CORRIGENDUM

ETS 300 187

Integrated Services Digital Network (ISDN);
Three-Party (3PTY) supplementary service
Functional capabilities and information flows

This corrigendum corrects some editorial mistakes in the first edition of ETS 300 187.

Figure 9.1: SDL diagrams for FE2

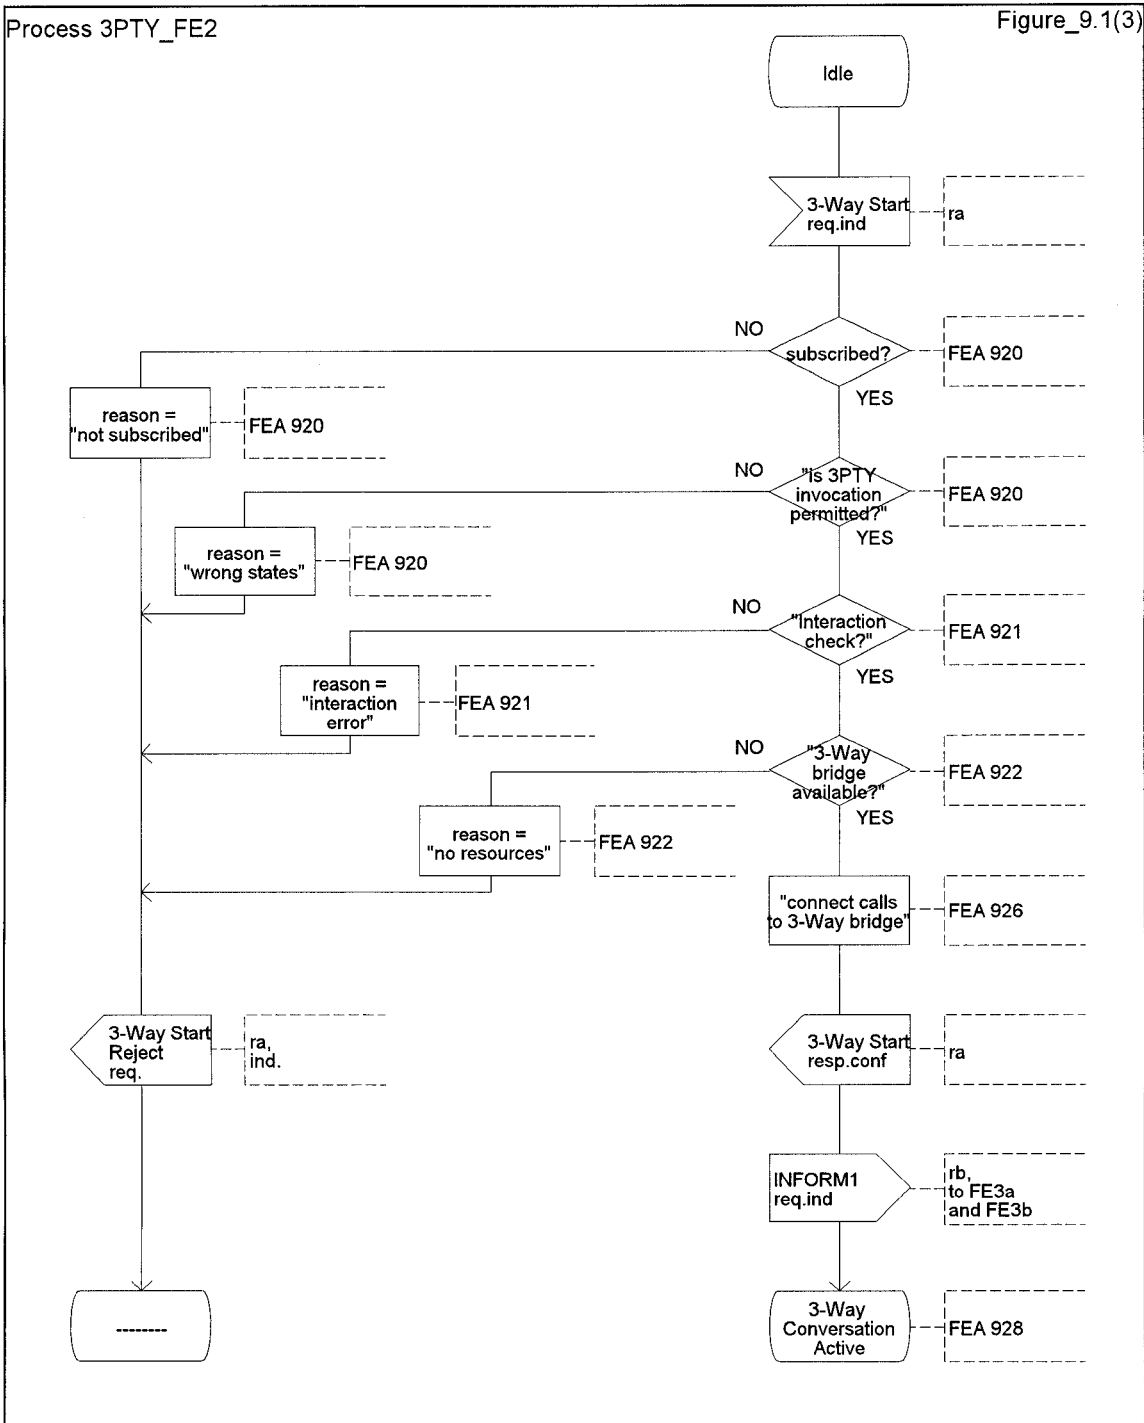
Page 22, amendment to subclause 8.2, figure 9.1

Delete the "parallel" output signal "INFORM1 req.ind" and update the text symbol.
